## SUBMITTAL RESPONSE

PROJECT NAME : PSE OTC

Item :	Joist & Metal Deck Shop Drawings
--------	----------------------------------

**PSE TRAINING CENTER PUYALLUP**  
 PUYALLUP, WA  
 PENNON CONSTRUCTION COMPANY INC.  
 GENERAL CONTRACTOR  
 SEI JOB NO: 43423

## ROOF FRAMING PLAN- NORTH

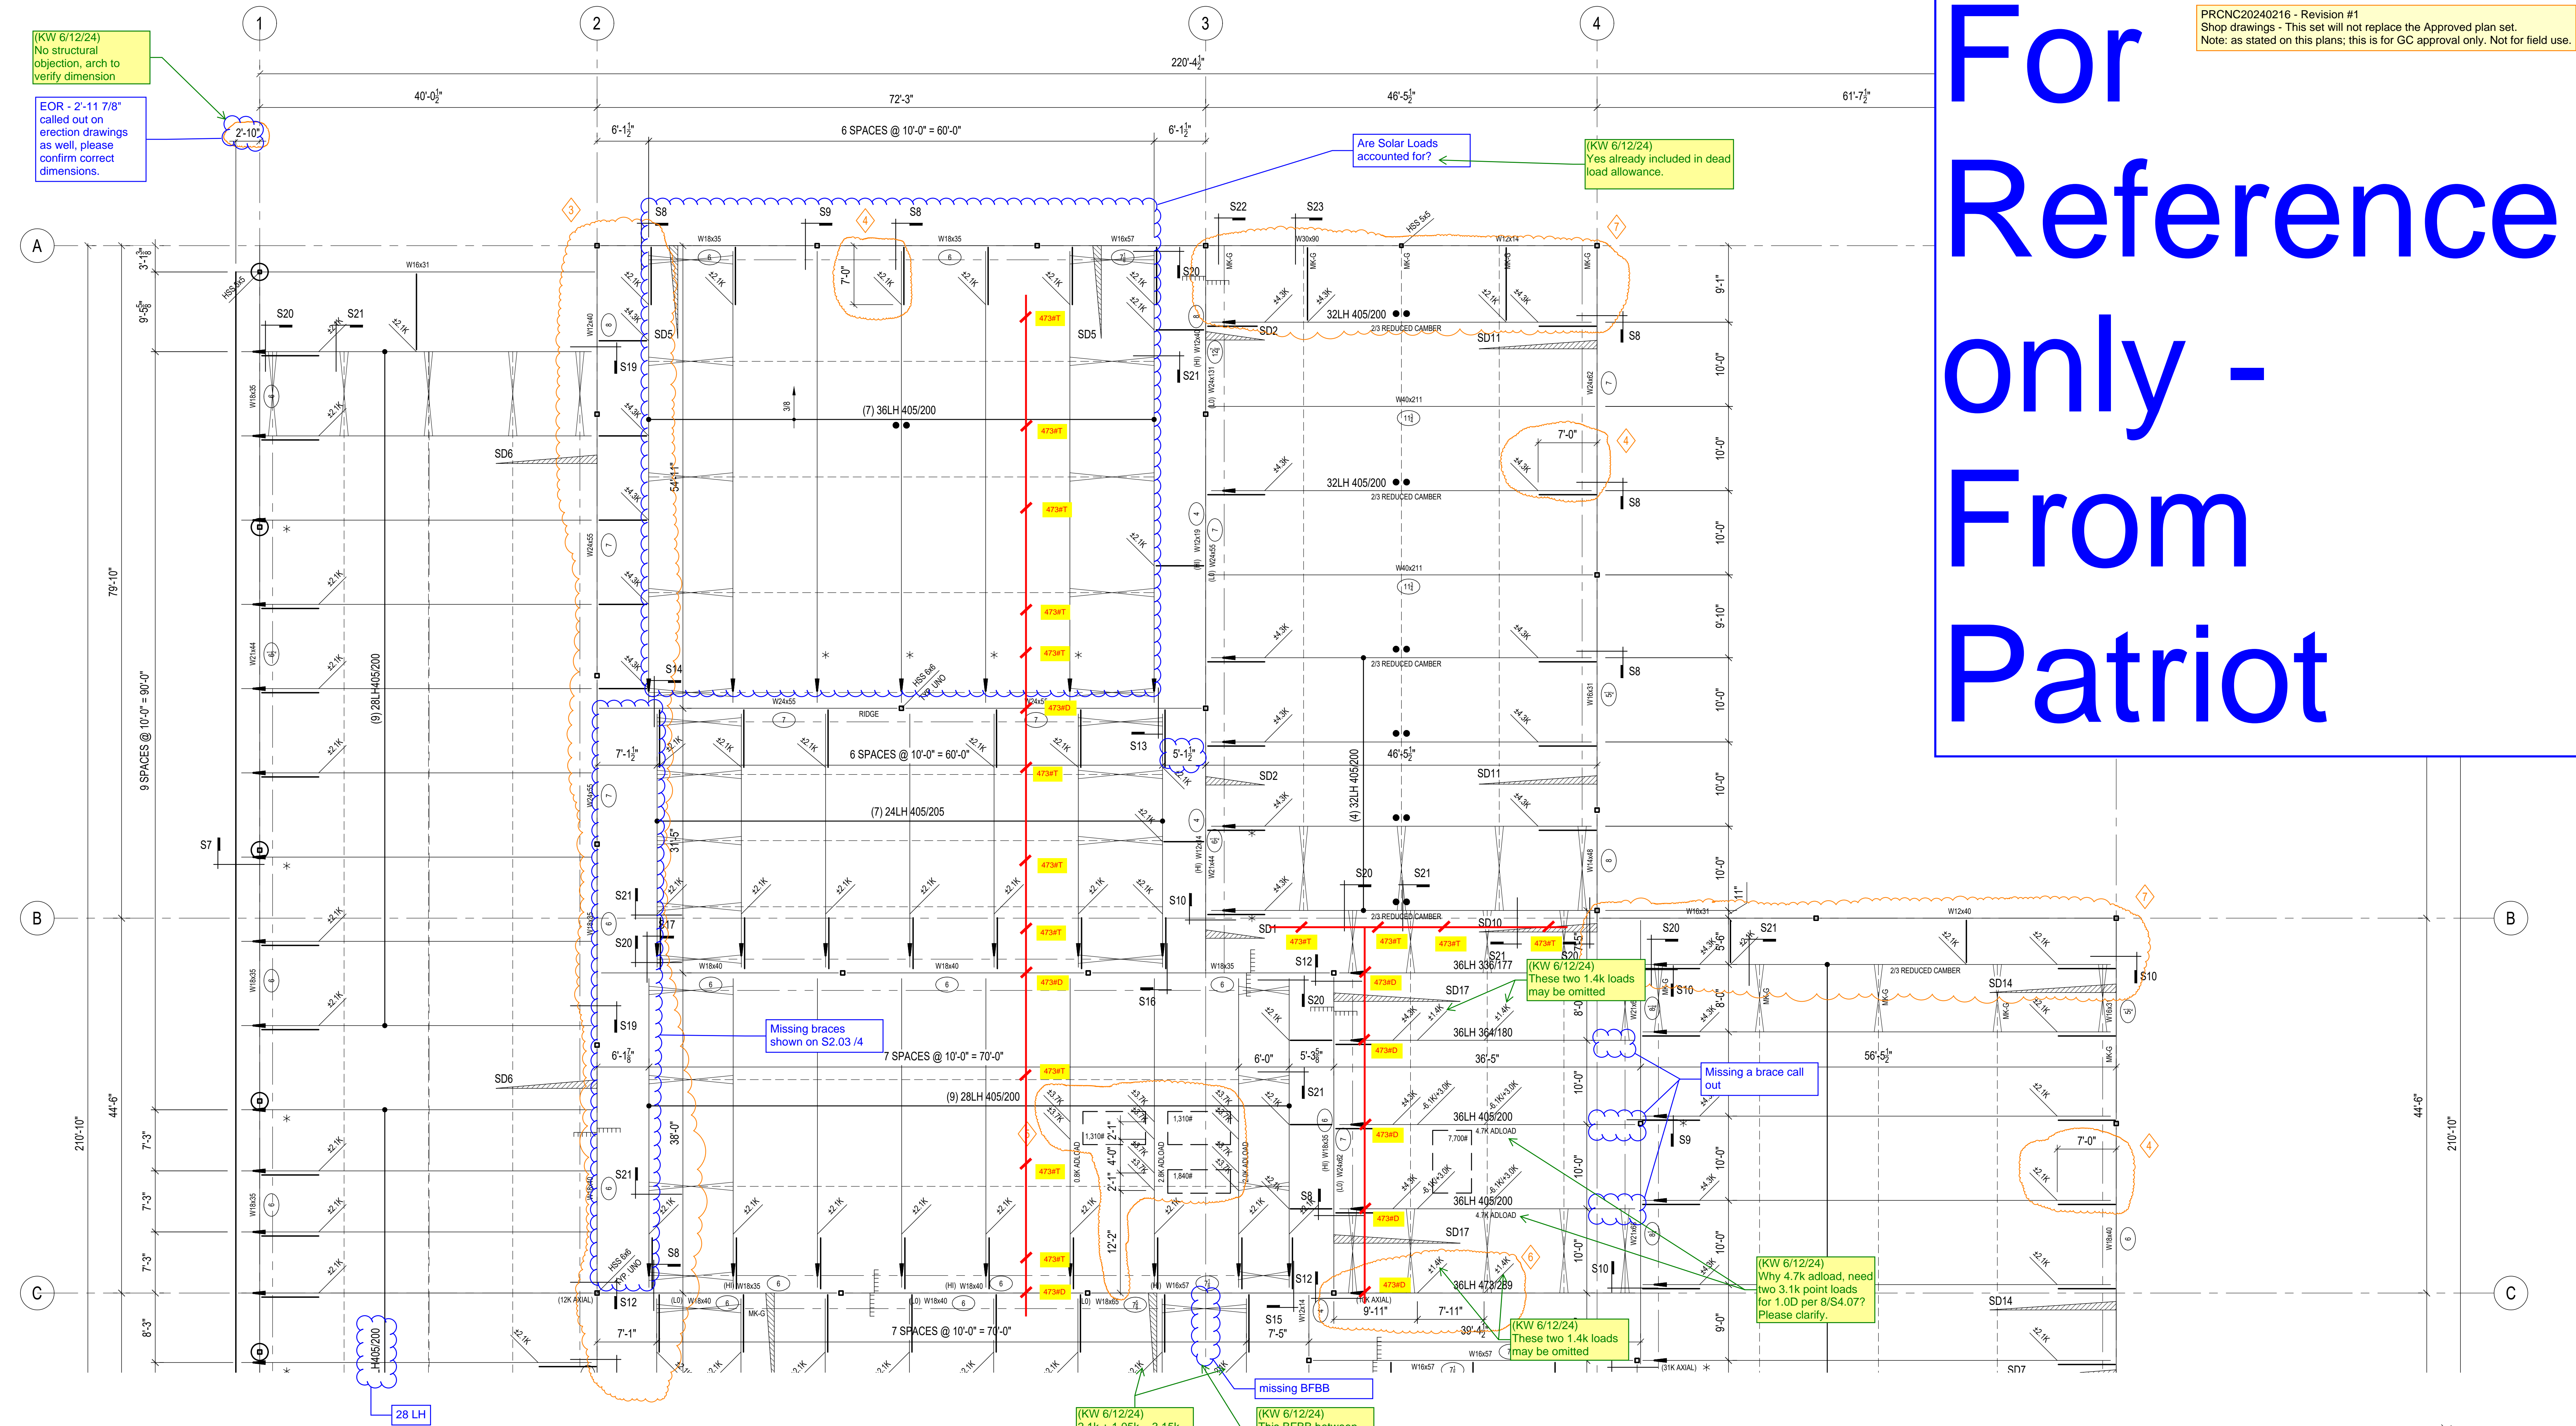
- Per EOR General notes Bracing and Bridging will be per SJ Drawings. If bracing and bridging beyond what is shown in SJ drawings is desired, EOR to provide specific locations and details in response to this submittal.
- Per EOR Conversation with Pennon, no Sprinkler Loads were accounted for in structural design. EOR to provide loading direction in response to this submittal.
- EOR to confirm Solar array loading is contemplated in their joist sizing, or provide direction of revision.
- Per EOR Conversation with Pennon, no Joist Hung VAV, FCU, or other mechanical loads were contemplated in their design. EOR to provide loading direction in response to this submittal.

- APPROVERS CHECKLIST:**
- PLEASE VERIFY JOISTS TOP CHORD EXTENSIONS DIMENSIONS FROM GRID 1 AS SHOWN. PROVIDE OTHERWISE.
  - PLEASE VERIFY IF ANY SNOW DRIFT LOAD APPLICABLE PERPENDICULAR TO JOISTS AT THIS GRID 2. IF SO, PLEASE PROVIDE LOAD.
  - PLEASE VERIFY 7'-0" DIMENSION FROM GRIDS TO UP/DOWN LOAD DUE TO BRACING. PROVIDE OTHERWISE.
  - PLEASE VERIFY UP/DOWN LOADS LOCATION FROM GRID C AS SHOWN. PROVIDE OTHERWISE.
  - PLEASE VERIFY UP/DOWN LOADS FROM BEAM SUPPORT OFF GRID 3 AS SHOWN. PROVIDE OTHERWISE.
  - PLEASE VERIFY IF ANY SNOW DRIFT LOAD APPLICABLE PERPENDICULAR TO JOISTS, DUE TO PARAPET, AT GRIDS A & B. IF SO, PLEASE PROVIDE LOAD.

- COLOR CODE: Bracing/bridging is per manufacturer, no additional requirements by KW
- SEE SHEET: Sprinkler lines 3" or smaller may be neglected in the OWSJ design. Larger lines shall have load accounted for. GC to coordinate with sprinkler submittal and mark hanger loads on joist submittal plan.
- SEE SHEET: HORIZONTAL BRACING: A uniform solar load allowance is included in the design dead load, no additional loads required for solar.
- PROVIDE ON EACH JOIST: SEE UPLIFT BRIDGING DIAGRAM ON SHEET CJ1. UPLIFT BRACING: The VAV weights are low enough to be accounted for in the uniform dead load. An Add-Load of 220 lbs shall be provided at all joists supporting FCU weights greater than 200 lbs. GC to coordinate locations and mark on plan for joist mfr. Provide chord reinforcement per 5/S4.07 where required.

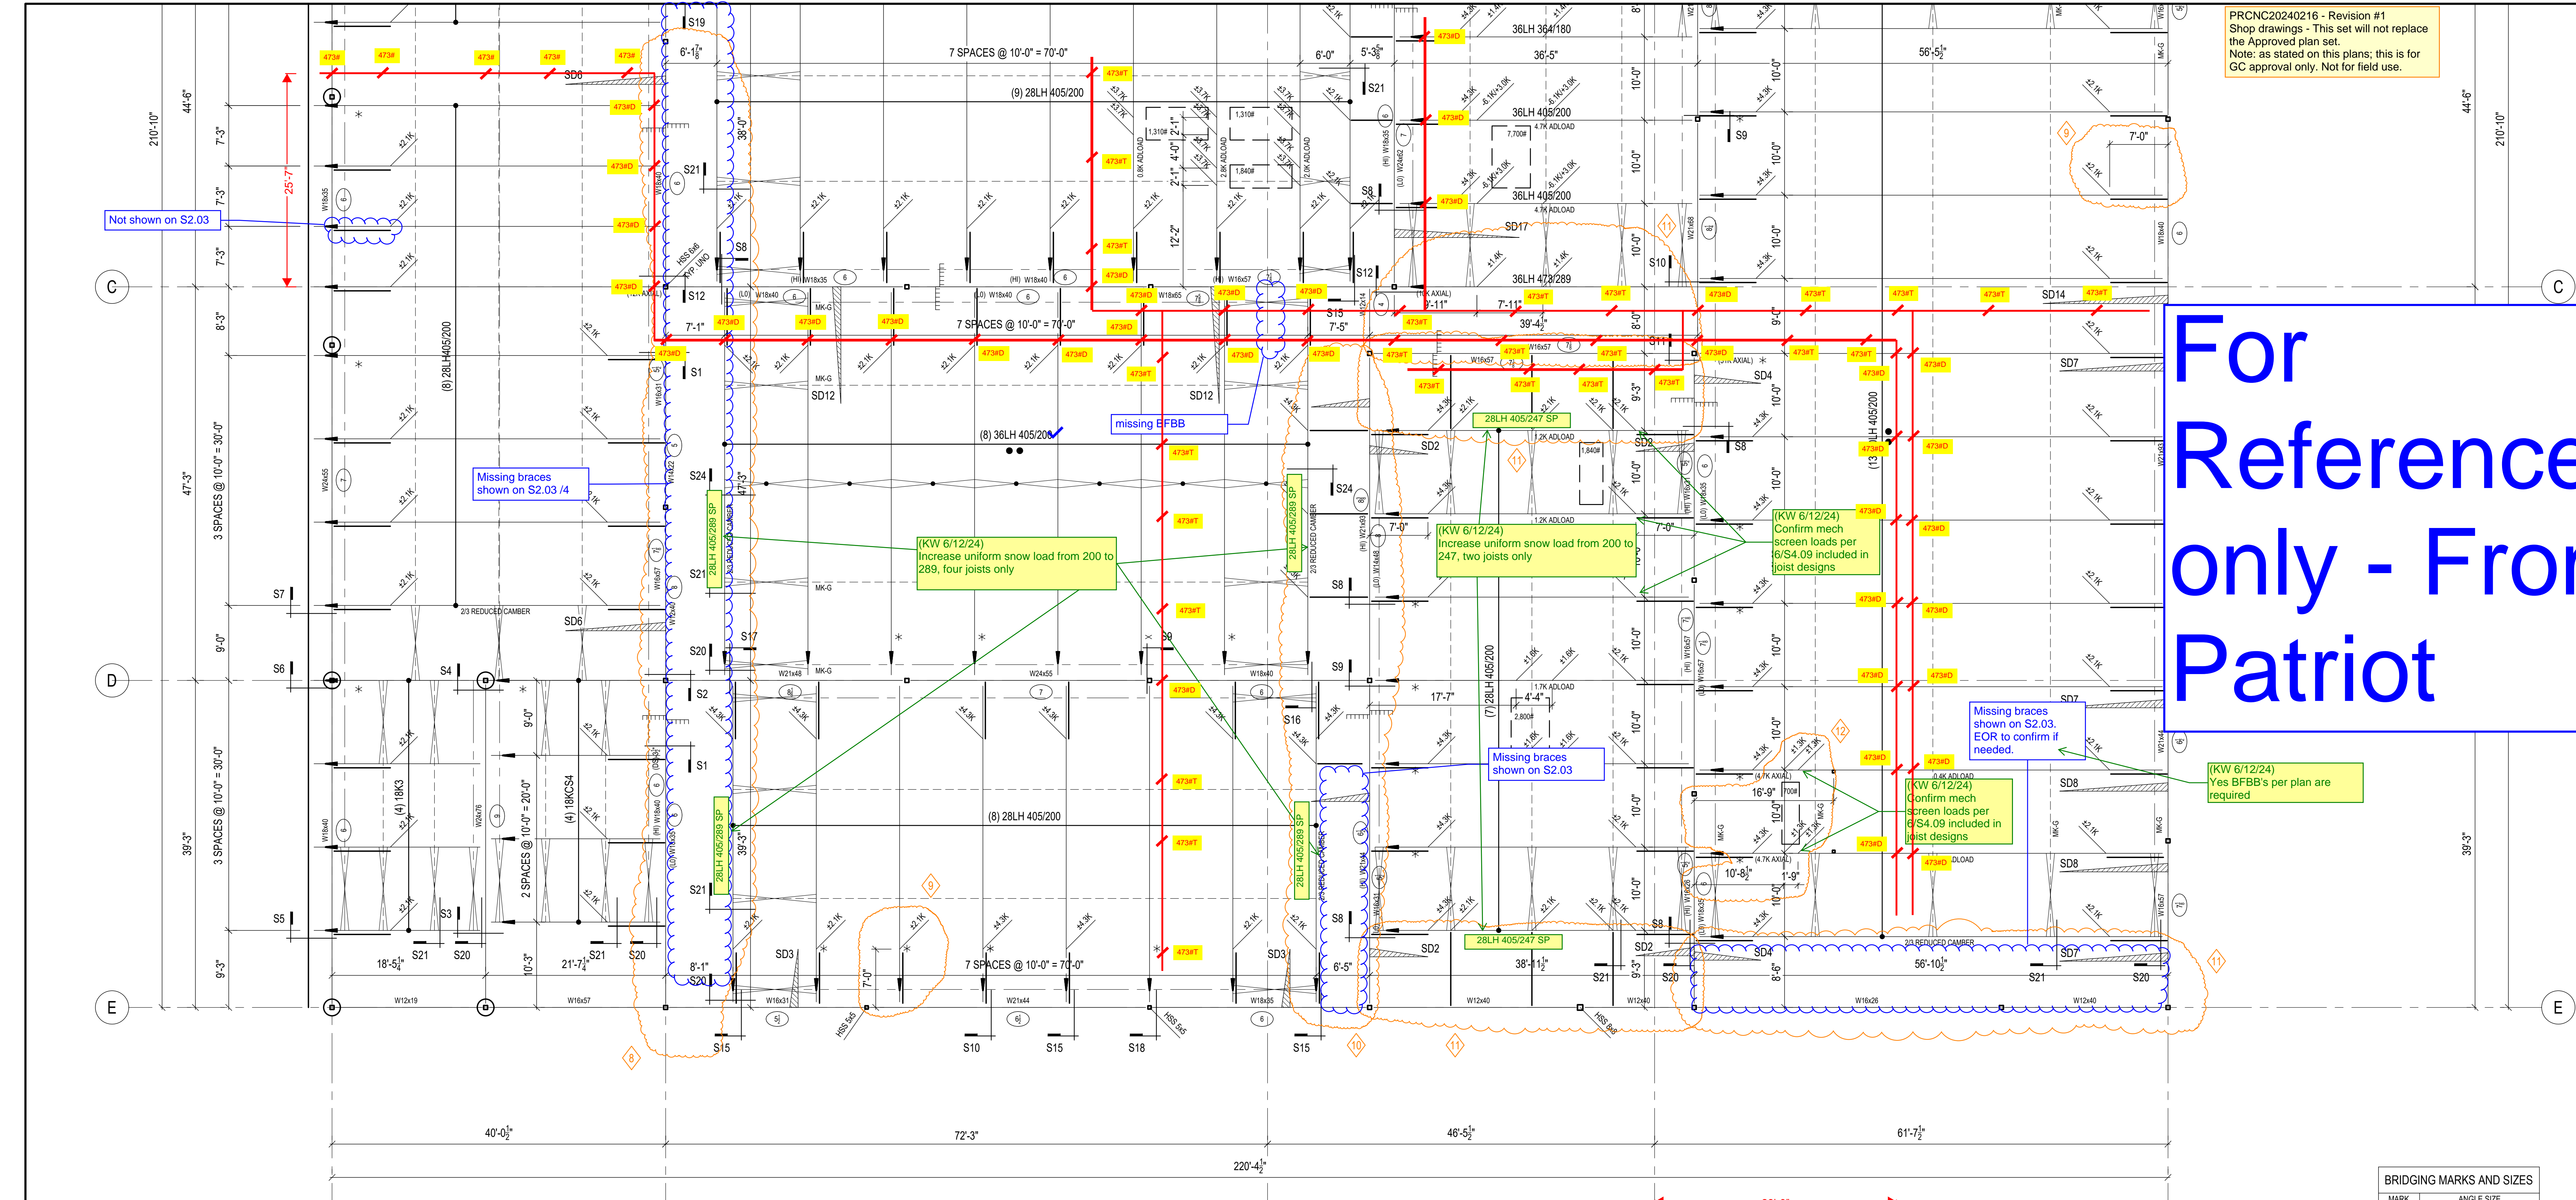
- Per EOR General notes Bracing and Bridging will be per SJI Drawings. If bracing and bridging beyond what is shown in SJI drawings is desired, EOR to provide specific locations and details in response to this submittal.
- Per EOR Conversation with Pennon, no Sprinkler Loads were accounted for in structural design. EOR to provide loading direction in response to this submittal.
- EOR to confirm Solar array loading is contemplated in their joist sizing, or provide direction of revision.
- Per EOR Conversation with Pennon, no Joist Hung VAV, FCU, or other mechanical loads were contemplated in their design. EOR to provide loading direction in response to this submittal.

- APPROVERS CHECKLIST:**
- PLEASE VERIFY IF ANY SNOW DRIFT LOAD APPLICABLE PERPENDICULAR TO JOISTS AT THIS GRID 2. IF SO, PLEASE PROVIDE LOAD.
  - PLEASE VERIFY 7'-0" DIMENSION FROM GRIDS TO UP/DOWN LOAD DUE TO BRACING TYP. PROVIDE OTHERWISE.
  - PLEASE VERIFY IF ANY SNOW DRIFT LOAD APPLICABLE PERPENDICULAR TO JOISTS AT PARAPET OFF GRID 3. IF SO, PLEASE PROVIDE LOAD.
  - PLEASE VERIFY IF ANY SNOW DRIFT LOAD APPLICABLE PERPENDICULAR TO JOISTS, DUE TO PARAPET AT GRID E. IF SO, PLEASE PROVIDE LOAD.
  - PLEASE VERIFY UP/DOWN LOADS LOCATIONS FROM BEAM SUPPORT OFF GRID 4 AS SHOWN. PROVIDE OTHERWISE.

(KW 6/12/24)  
 Sprinkler lines 3" or smaller may be neglected in the OWSJ design. Larger lines shall have load accounted for. GC to coordinate with sprinkler submittal and mark hanger loads on joist submittal plan.

(KW 6/12/24)  
 The VAV weights are low enough to be accounted for in the uniform dead load. An Add-Load of 220 lbs shall be provided at all joists supporting FCU weights greater than 200 lbs. GC to coordinate locations and mark on plan for joist mfr. Provide chord reinforcement per 5/S4.07 where required.
